FAAC-INFO

TECHNICAL SERVICES DEPT.

Date: May 5, 2005	Vol. # 013
Subject: 615/620 Barriers	Reason For Info: Beam Brackets

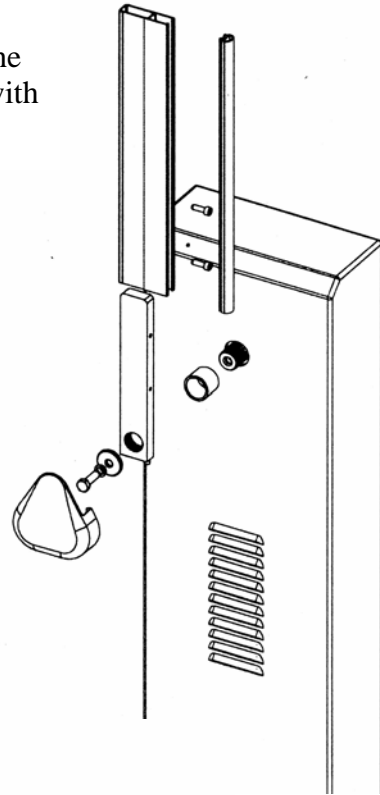
New style Barrier with the new Beam Bracket being installed. The spacer and screws are included with the beam bracket.

New style Beam Bracket and Beam being installed on an pre-September 2005 Barrier. The Adaptor kit shown ***must*** be used in place of the new spacer and 12 mm bolt.
